The revised manuscript has been substantially improved after the first-round review. The authors have added clearer positioning of the work as a system-level LST product-generation framework rather than as a set of new individual algorithms; they have expanded the validation with OzFlux sites, added representativeness screening for in-situ sites, introduced bias correction for the VNP21A1 cross-validation, and provided additional diagnostics for cloud filling and downscaling uncertainties. These changes address many of the main concerns raised in the first round. The revised manuscript now presents a more coherent and better supported dataset paper for an hourly, angular-normalized, cloud-filled, and 0.01° downscaled FY-4A LST product from 2018 to 2023. The dataset is potentially valuable for the LST, surface radiation, evapotranspiration, and land-atmosphere interaction communities, especially because the product provides directional, nadir, and hemispherical LST layers rather than only a conventional directional LST field. The authors also now explicitly state that the novelty is mainly in the unified processing chain and angular consistency of the final product, not in each indi

Fig. R1 The accuracy of all-weather hemispherical LST products (a) before and (b) after downscaling.

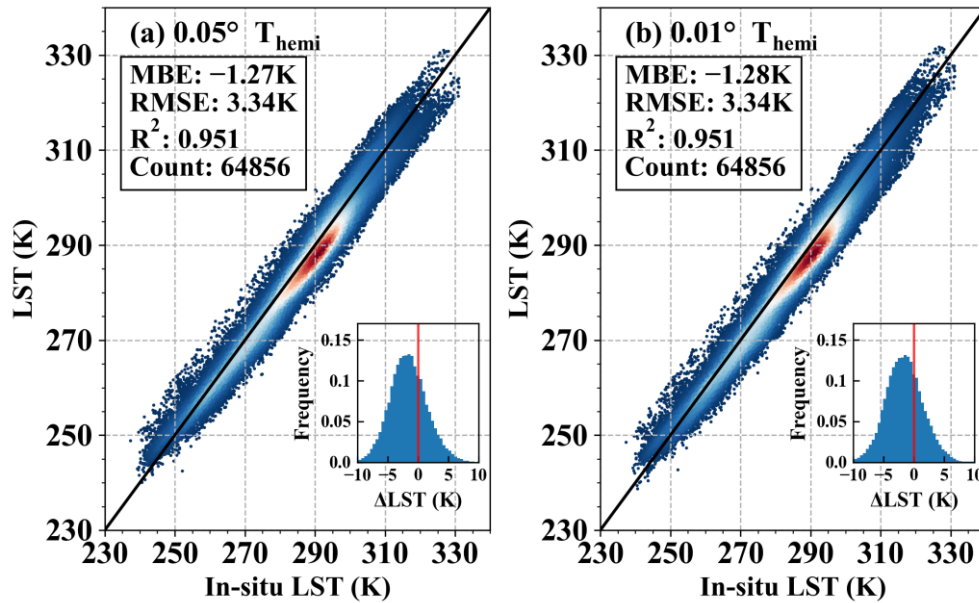
1. The final 0.01° product is not independently validated.

The manuscript validates the angular-normalized nadir LST mainly at 0.05° against bias-corrected near-nadir VNP21A1, and validates 0.05° all-weather hemispherical LST against in-situ pyrgeometer-derived LST. The downscaling step is evaluated mainly through model fitting RMSE and texture similarity metrics using ATC-derived texture as reference. This is useful, but it does not constitute an independent accuracy assessment of the final 0.01° product. Since the released dataset is the 0.01° ANCFDS-LST, the authors should either provide a direct validation of the final 0.01° product at the in-situ sites, or clearly state that the absolute temperature accuracy assessment is primarily for the 0.05° product and that the 0.01° assessment is limited to spatial texture consistency. A comparison with Landsat/ECOSTRESS clear-sky LST for selected regions and dates would further strengthen the paper, but at minimum the existing validation claims should be carefully qualified.

Response: Thank you for your detailed suggestion regarding the validation of the 0.01° downscaled LST product. We acknowledge that the validation in the original manuscript mainly focused on spatial texture evaluation, while the direct accuracy assessment of the final 0.01° product was insufficient. Following your suggestion, we additionally evaluated both the 0.05° and 0.01° LST products against in-situ LST measurements for daytime/nighttime and all-weather conditions. As shown in Fig. R1, the RMSE (MBE) is 3.34 K (-1.27 K) for the 0.05° LST and 3.34 K (-1.28 K) for the downscaled 0.01° LST. The nearly unchanged accuracy indicates that the downscaling process introduces very limited additional uncertainty. Another reason is that the validation sites were strictly screened to ensure strong spatial representativeness at both 0.05° and 0.01° scales, thus the retrieved LSTs at the two scales exhibit comparable accuracy.

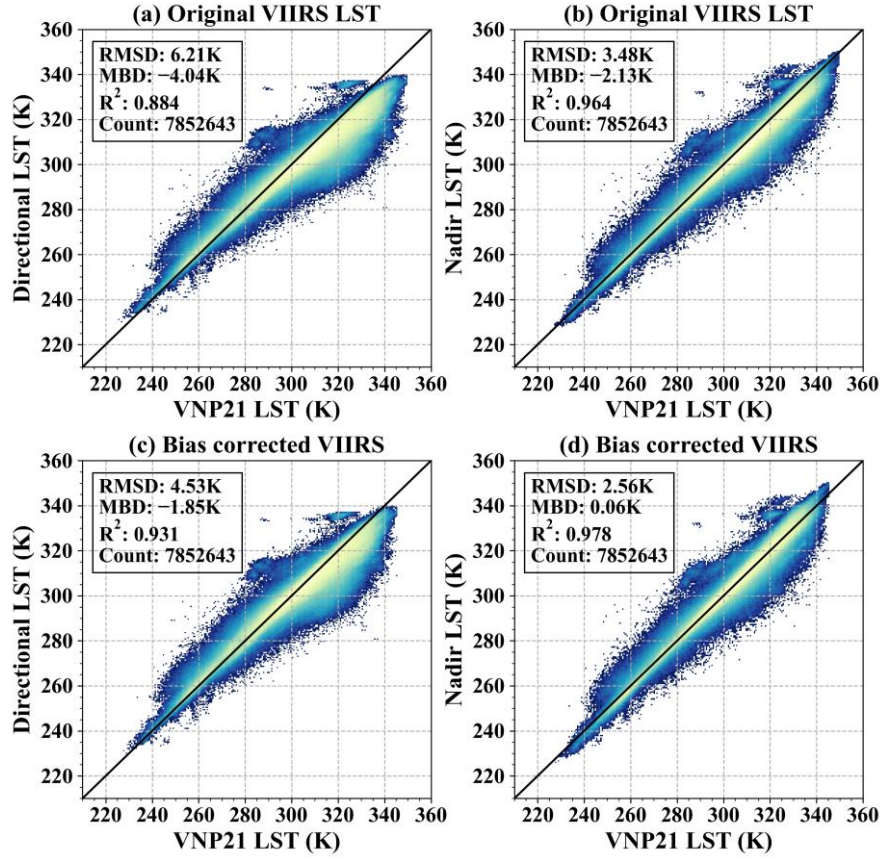
3. Clarify the temperature scale after FY-4A–MODIS and FY-4A–VIIRS bias corrections.

The manuscript states that FY-4A LST was linearly adjusted to match MODIS MxD11A1 before TEKDM calibration, with slope 1.0240 and intercept −5.7378. It also states that VNP21A1 was bias-corrected to FY-4A using nighttime matchups before cross-validation. This is methodologically reasonable for reducing inter-sensor systematic differences, but it creates ambiguity about the final product’s radiometric reference scale. Are the released T_{dir} , T_{nadir} , and T_{hemi} values on the original FY-4A official LST scale, the MODIS-adjusted FY-4A scale, or a hybrid scale? The authors should state this explicitly. In addition, the VNP21A1 cross-validation results should preferably include uncorrected and bias-corrected metrics, at least in a supplement, so that readers can separate angular-normalization improvement from inter-sensor bias removal.

Response: Thank you for your insightful suggestion regarding the temperature scale after bias correction. Following Ermida et al. (2018), we first corrected FY-4A LST to the MODIS temperature scale before TEKDM calibration, and the subsequent cloud-filling and downscaling procedures were all based on the corrected LST. Therefore, the released T_{dir} , T_{nadir} , and T_{hemi} products are all provided on the MODIS-referenced FY-4A temperature scale rather than the original FY-4A operational LST scale. We have clarified this explicitly in the revised manuscript. In addition, we agree that it is important to distinguish the improvement from angular normalization and that from inter-sensor bias correction. Therefore, we provided cross-validation results using VIIRS near-nadir LST before and after bias correction as you suggested. For directional LST, the RMSD (MBD) decreases from 6.21 K (-4.04 K) before bias correction to 4.53 K (-1.85 K) after bias correction, indicating an improvement of 1.68 K in RMSD and 2.19 K in MBD due to bias adjustment. After angular normalization, the nadir LST achieves RMSD (MBD) values of 3.48 K (-2.13 K) before VIIRS bias correction and 2.56 K (0.06 K) after bias correction. This supplementary information allows readers to better separate the contributions from inter-sensor bias removal and angular normalization. Thank you again for your constructive suggestions.

Fig. R3 Validation of FY-4A (a) clear-sky and (b) cloud-sky LST without site screening.

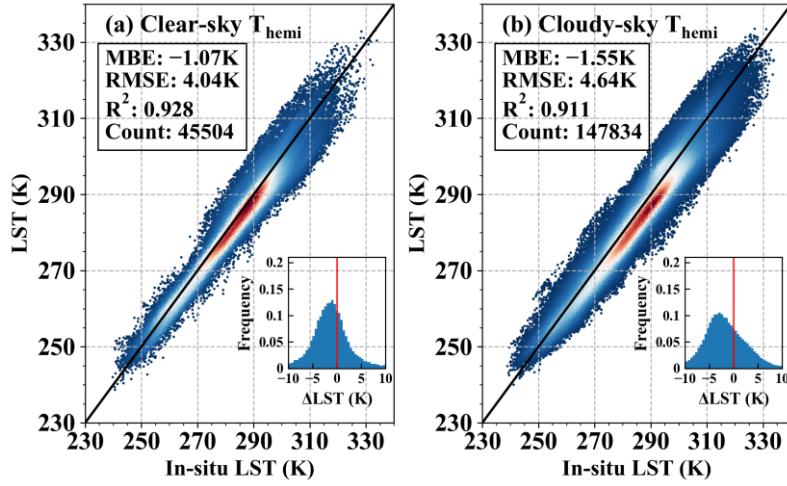
4. The representativeness-based site selection improves validation quality but may also introduce selection bias.

The revised validation uses eight sites selected from HiWATER, OzFlux, and Tibetan Plateau candidates based on Landsat LST spatial STD and nighttime FY-4A–in-situ RMSE. This is a reasonable way to ensure spatial representativeness, but because one of the screening criteria uses the agreement between FY-4A and in-situ LST, the final reported validation accuracy may be optimistic relative to the full range of surface conditions within the FY-4A disk. I recommend that the authors briefly report the validation statistics for all candidate sites, or at least state how much the RMSE changes before and after site screening. The response document mentions that the original clear/cloudy RMSE values were 2.99 K and 4.56 K and improved to 2.48 K and 3.65 K after site replacement/screening; this useful information should be included in the manuscript or supplement.

Response: Thank you for your valuable suggestion regarding the potential selection bias introduced by the representativeness-based site screening. We agree that using the nighttime FY-4A–in-situ RMSE may lead to relatively optimistic validation statistics. Following your suggestion, we additionally reported the validation results before site screening as supplementary information (Fig. R3). The clear/cloudy RMSE values were 4.04 K and 4.64 K (including all the 28 candidate sites), and improved to 2.48 K and 3.65 K after site screening (including 8 selected sites). In addition, we have revised the manuscript to explicitly provide the representativeness indicators for each selected site, including the Landsat 8 LST STD and the RMSE between nighttime FY-4A LST and in-situ LST, allowing readers to better assess the reliability and representativeness of the selected validation sites. Thank you again for your insightful suggestion.
